1 # RC2

11 This manuscript addresses groundwater recharge processes in a gully system and aims to quantify
12 recharge rates and pathways using hydrometric, isotopic, and geochemical approaches. While the
13 topic is potentially interesting and relevant to HESS, the manuscript in its current form is poorly
14 written, excessively long, and lacks a clear narrative structure. Moreover, the presentation of the
15 results makes it difficult to assess whether the data adequately support the authors' conclusions.
16 Interpretations are frequently motivated by background knowledge or earlier studies, yet the
17 manuscript does not clearly distinguish between new insights derived from this work and those that
18 primarily serve as contextual or corroborative information. This lack of separation between novelty
19 and background substantially weakens the scientific message. I think substantial revision is required

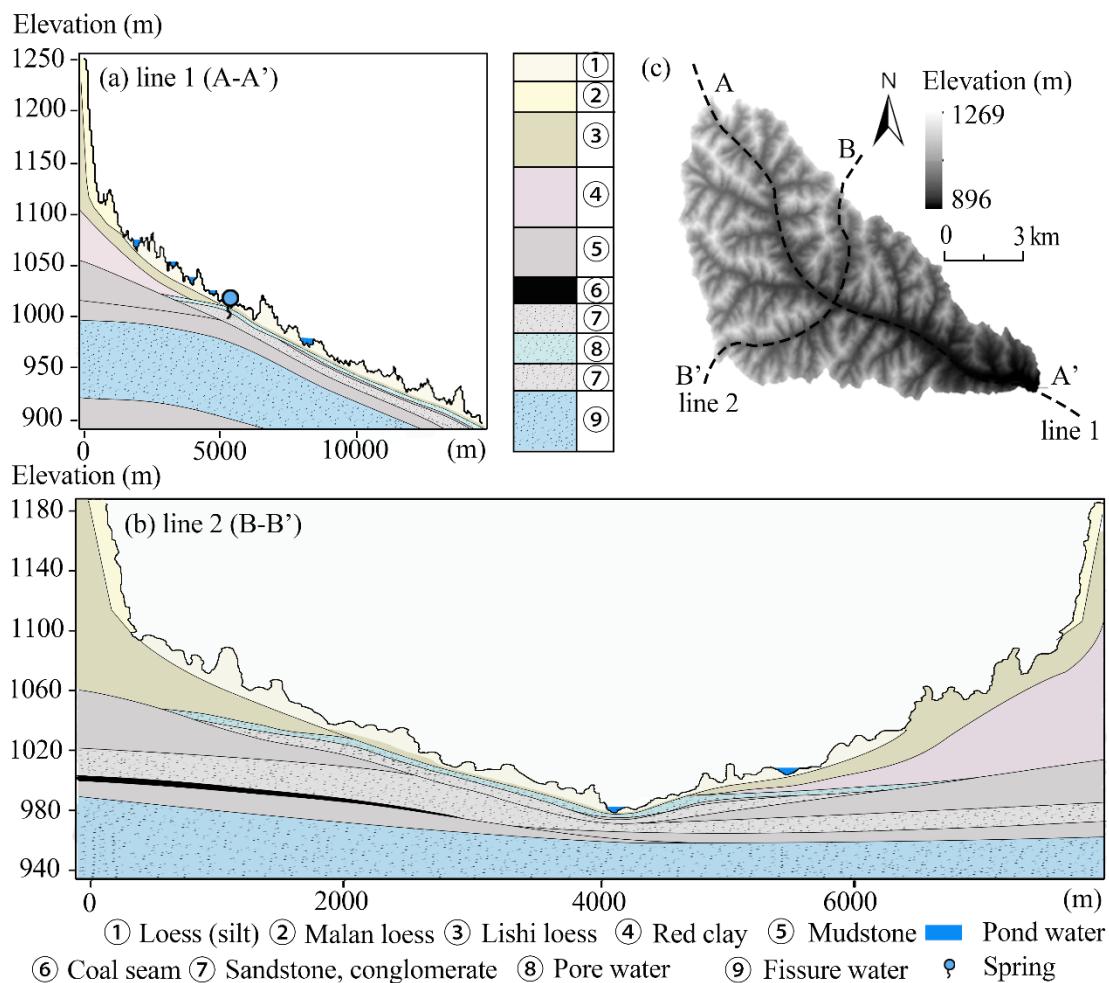
508 1. Fig. 1: Please label the horizontal and vertical scale of the hillslope profile. Without scale
509 information, the geomorphic interpretation is unclear. And consider to switch the order of Fig. 1 and
510 2.

511 **Response:** Following your comment, we have added clear scale information to the hillslope profile.
512 Specifically, both horizontal and vertical scale bars have been included to ensure a clear and accurate
513 interpretation of the geomorphological features. The revised Fig. 2 (in the revised manuscript) is as
514 follows:

521 In response to General comment #1, we have relocated Fig. 1 to the “2. Sampling Sites” section
 522 and swapped the order of Fig. 1 and 2. This adjustment ensures that the figures are arranged logically
 523 to align with the structure of the section content.

288 Fig. 7. Chloride concentration of various water sources in the rainy and dry seasons (a), and the
289 spatial relationship between chloride concentration and $\delta^{18}\text{O}$ for different water sources (b)."

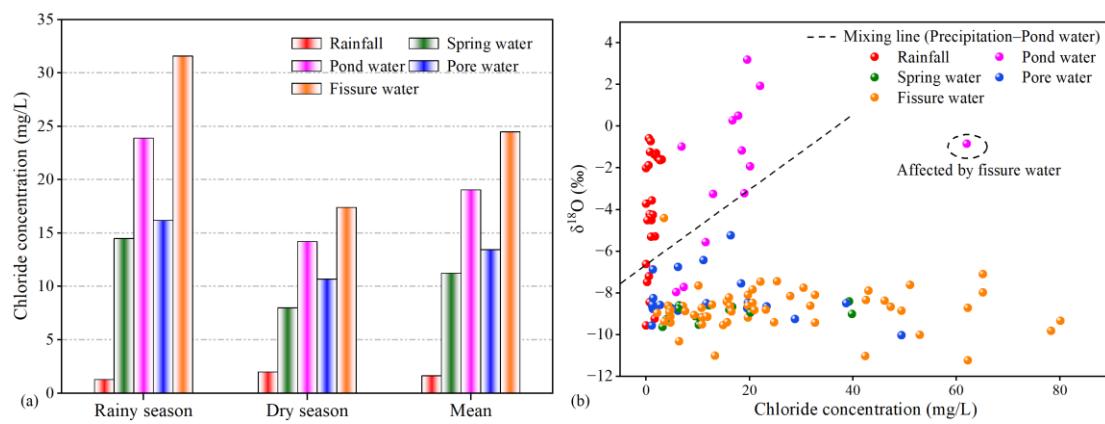
268 • Lines 547–552: The argument that similarities in chloride concentrations between pond water and
269 pore water indicate mixed recharge is not logically developed. Chloride patterns alone do not
270 necessarily imply source mixing without additional constraints (e.g., conservative behavior, spatial
271 gradients, mass balance, or exclusion of evaporative concentration effects). The logic linking
272 chloride distributions to the stated conclusions should be clarified and strengthened, or the claims
273 should be toned down.

274 **Response:** Based on your comments, to strengthen the logical rigor of the conclusion regarding the
275 similarity in chloride concentrations between pond water and pore water, we first confirmed the
276 differences in chloride concentrations among various water sources. We then introduced the spatial
277 relationship between $\delta^{18}\text{O}$ and chloride concentrations to further compare concentration variations
278 across different water bodies at distinct locations. The results indicate a correlation between the
279 distribution patterns of chloride concentrations and $\delta^{18}\text{O}$, providing additional support for the

282 "Complementing the isotope data, Cl^- levels in pore water consistently fall between those of
283 precipitation and pond water across both seasons (Fig. 7a), and the correlation pattern between
284 chloride concentration and $\delta^{18}\text{O}$ supports a mixed recharge origin for pore water (Fig. 7b). This trend
285 aligns with the isotopic evidence from the rainy season and supports the interpretation that pond
286 water contributes to pore water recharge via vertical percolation through the vadose zone,
287 particularly during high-rainfall periods when infiltration capacity is exceeded.

406 **“5.4. Revised conceptual model”**

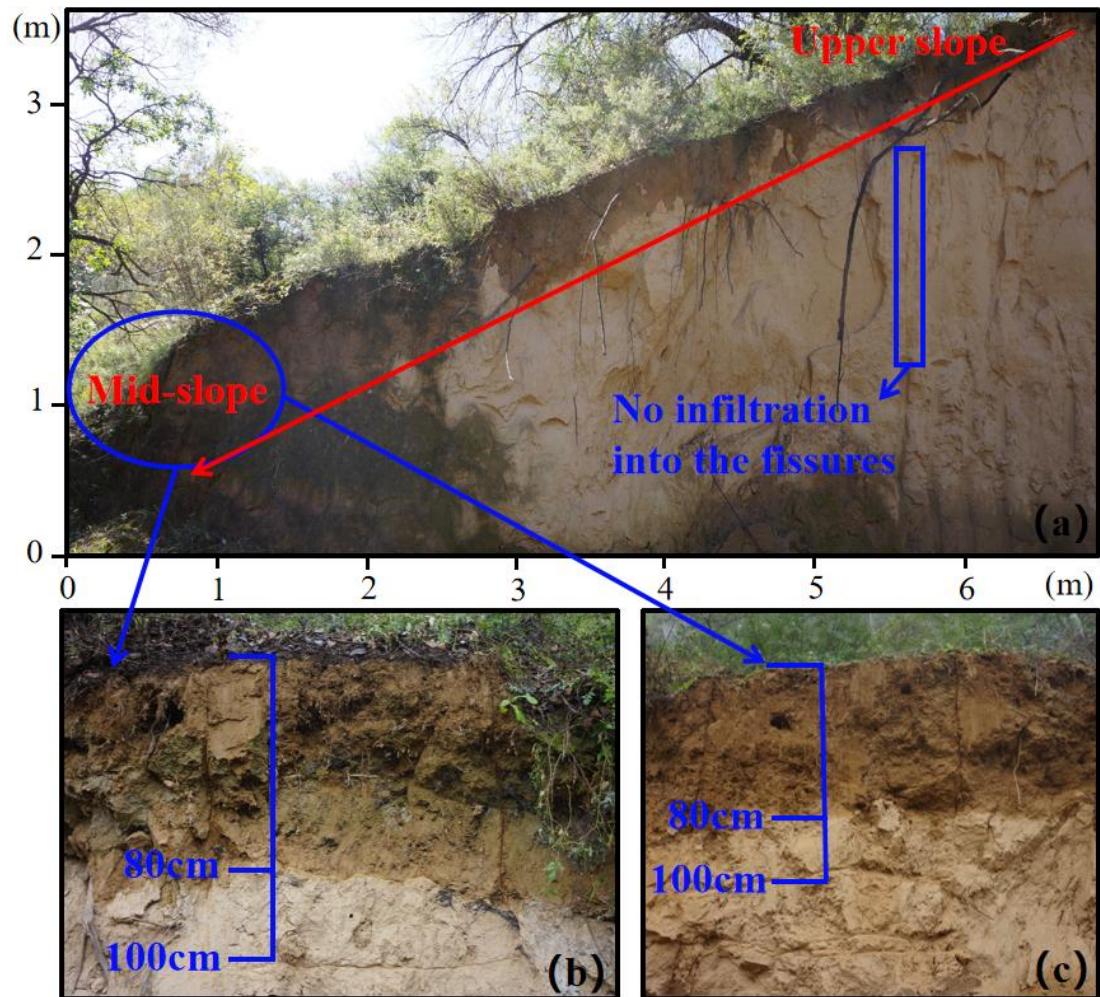
375 4. Hill versus gully. The results presented in this study are derived exclusively from the gully system,
376 and the manuscript does not include a direct comparison of recharge behavior between hill and gully
377 settings at the same site and during the same period. As such, the authors should be very cautious in
378 how they frame both the Introduction and the Conclusions, particularly where broader contrasts
379 between hill and gully recharge processes are implied. Given the absence of contemporaneous
380 hillslope observations, statements suggesting relative differences in recharge magnitude or
381 pathways between hill and gullies should be clearly identified as inferences based on previous
382 studies, rather than findings derived from the present work. This distinction is especially important
383 in the conceptual framework and schematic figures, where hill processes appear alongside gully

384 processes without sufficiently clear attribution. One example is the conceptual figure (Fig. 10). I
385 recommend that the authors:

- 386 • Explicitly state which components or pathways are supported by results from this study and which
387 are drawn from previous literature;
- 388 • Redraw the figure to include quantitative or semi-quantitative information (e.g., relative
389 magnitudes, ranges, or percentages of pathways) where supported by data.

390 In its current form, the conceptual figure does not clearly highlight new insights generated by this
391 study, and instead risks reinforcing a narrative largely based on prior work.

401 Following your comment, we have redrawn Fig. 10 (in the original manuscript, and now Fig.
402 11 in the revised manuscript) to clearly define the spatial scope of this study as the gully area, with
403 specific annotations for clarity. Accordingly, we have systematically reviewed and revised the
404 Discussion section to ensure that all analyses, inferences, and conclusions are tightly focused on the
405 hydrological processes within the gully area. The revisions are as follows:

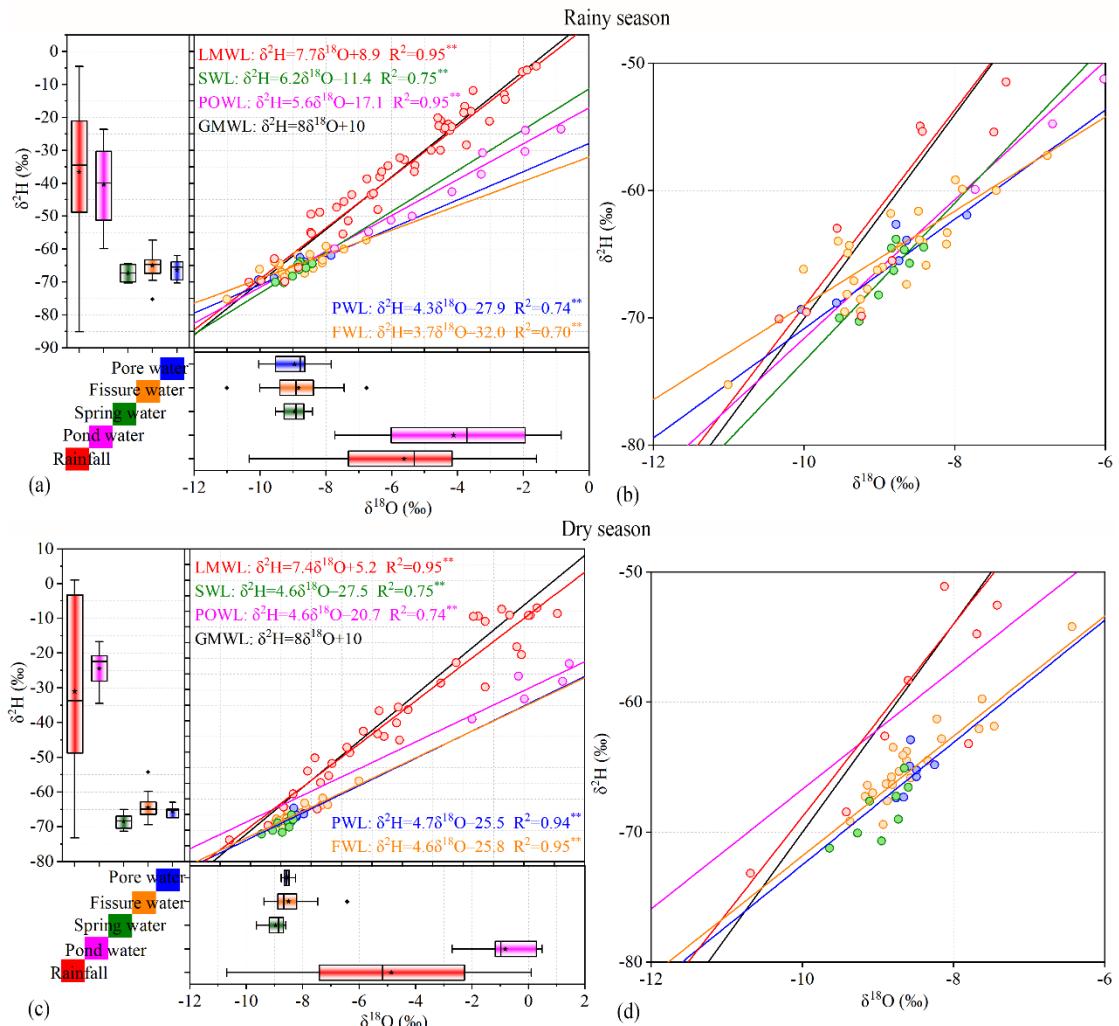
571
572
573
574 4. Fig. 5: The current representation of rainy versus dry seasons is unclear. The figure does not
575 effectively illustrate isotopic differences between seasons, making the associated text difficult to
576 support. Presenting seasonal mean values (or distributions) for each water type would likely convey
577 the message more clearly.

578 **Response:** We agree with your comment that Fig. 5 provides relatively limited information on

579 isotopic data for the wet and dry seasons. To more systematically and comprehensively present the
 580 seasonal characteristics of isotopic values across various water bodies, we have supplemented the
 581 data in Fig. 6 and Table A2 in the original manuscript. Specifically, the box plots in Fig. 6 visually
 582 display the distribution range, median, and variability of $\delta^{18}\text{O}$ and $\delta^2\text{H}$ for each water source during
 583 both wet and dry seasons, facilitating comparison of overall seasonal differences and variation
 584 patterns. Table A2 provides statistical metrics, such as mean values and standard deviations, for each
 585 water type's isotopes during both seasons, enabling a quantitative comparison. The specific details
 586 are as follows:

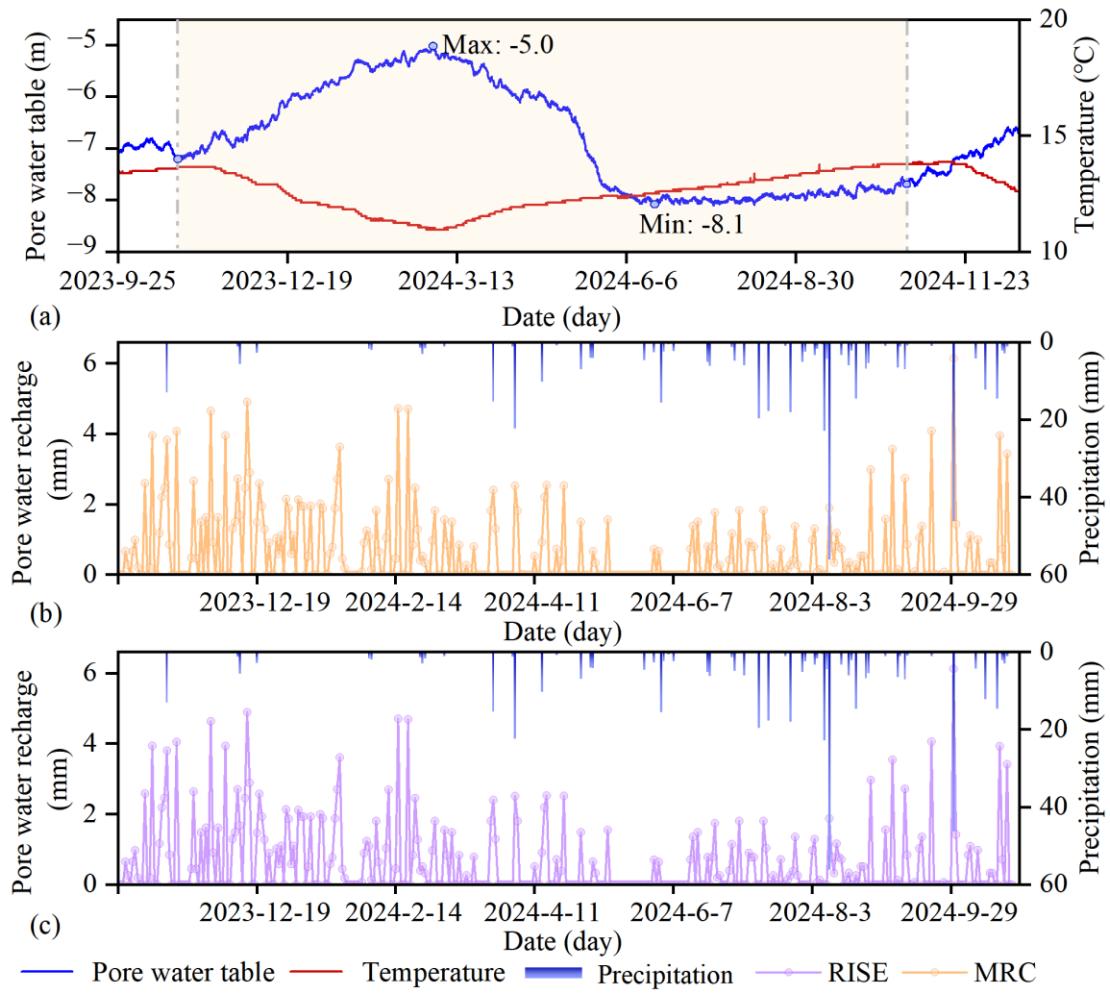
598 5. Fig. 8: The meaning of “direct effects” and “total effects” is not clearly explained. Please clarify
599 these terms explicitly in the caption and main text.

600 **Response:** Following your comment, we have added explanations of “direct effects” and “total
601 effects” in the figure caption and methods section of the manuscript.

612 Within the SEM framework, path relationships are primarily explained through two types of
613 effects: The direct effect refers to the immediate impact of one variable on another through a single
614 path, typically quantified as a standardized regression coefficient. Total effect represents the overall
